City Hall and Square Competition;  
Supplementary Questions and Answers.

**TO ALL COMPETITORS, CITY HALL AND SQUARE COMPETITION,  
TORONTO, CANADA :**

## CITY HALL AND SQUARE COMPETITION TORONTO, CANADA

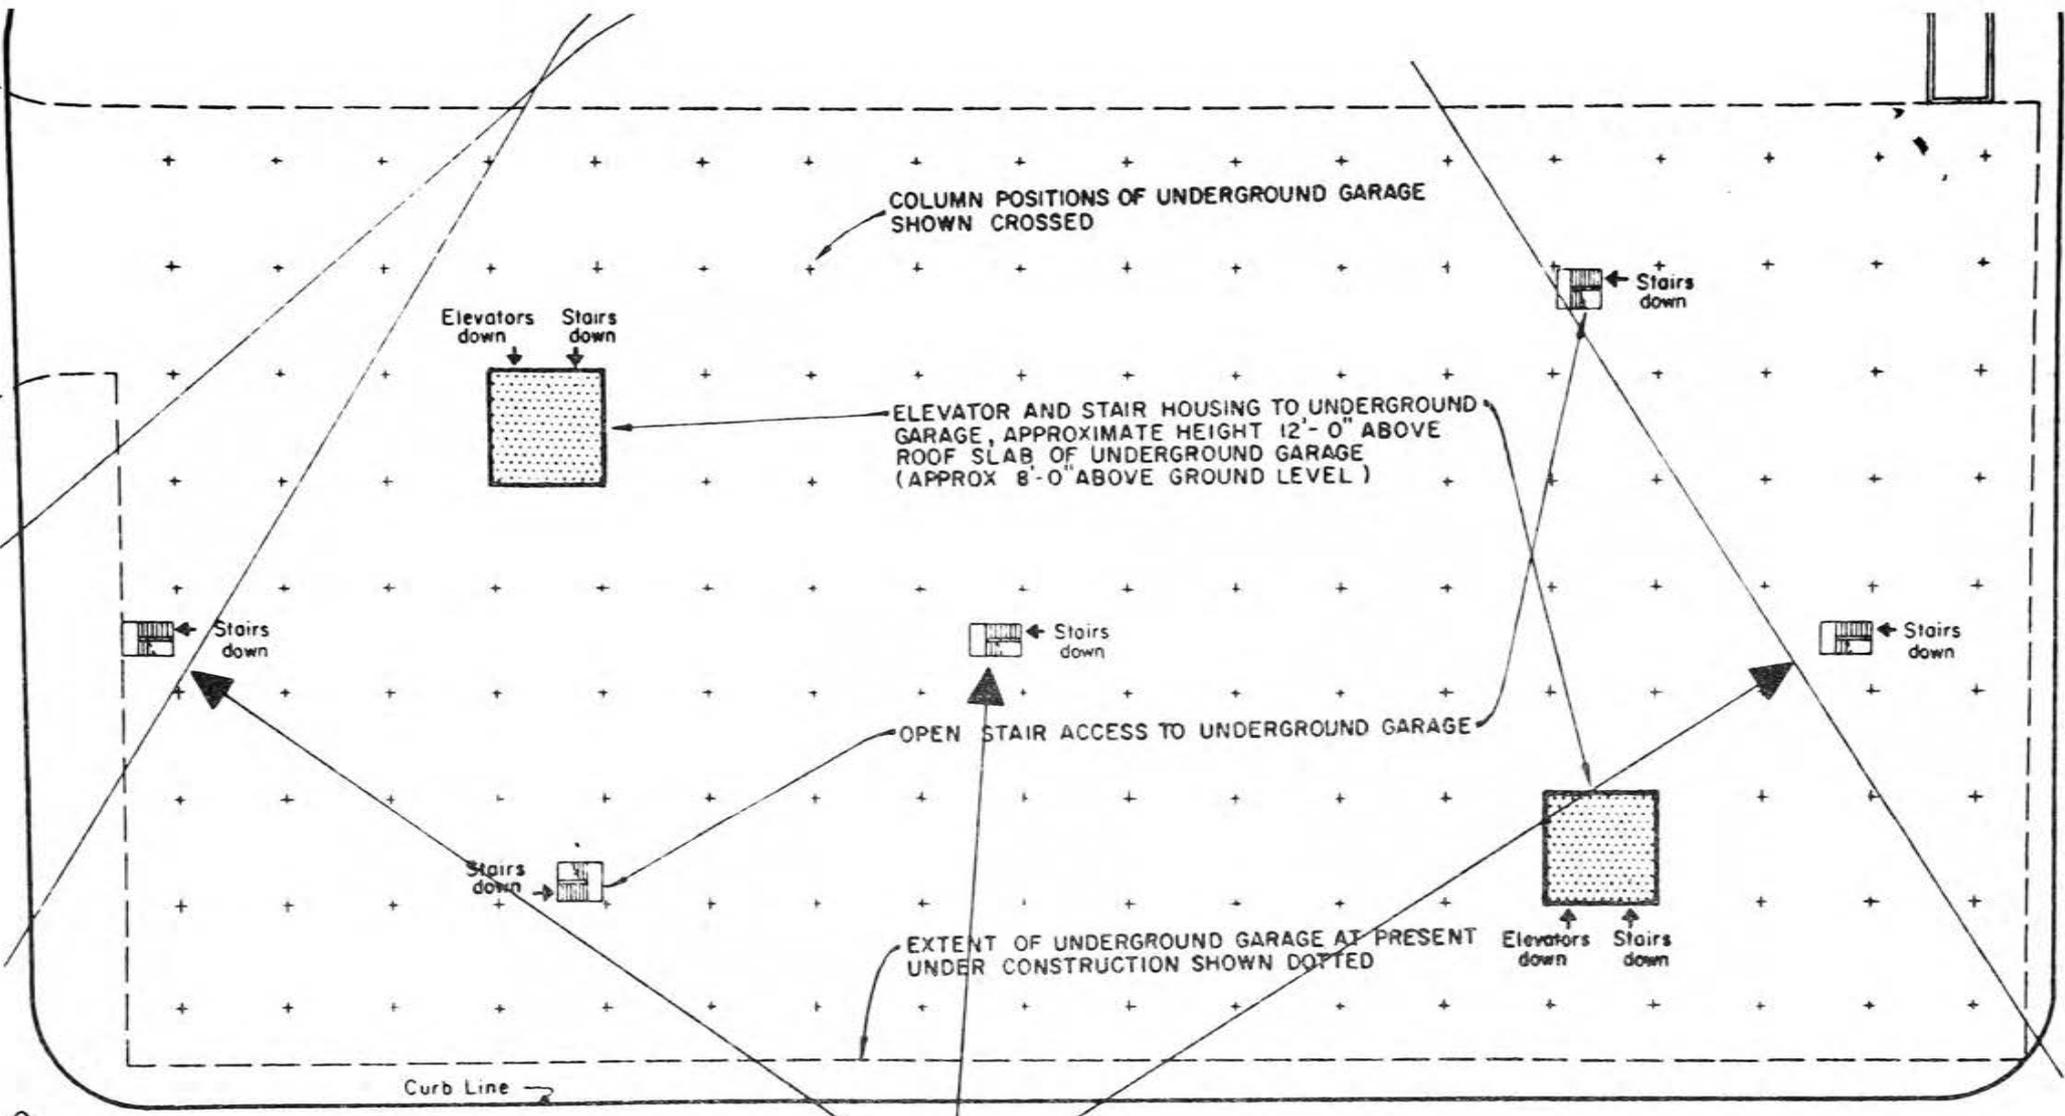
7. New open stair access points to the underground garage. (See Map.)

SINCE PUBLICATION OF THE COMPETITION PROGRAMME  
THREE NEW OPEN STAIR ACCESS POINTS TO THE  
UNDERGROUND GARAGE HAVE BEEN ADDED AS SHOWN.
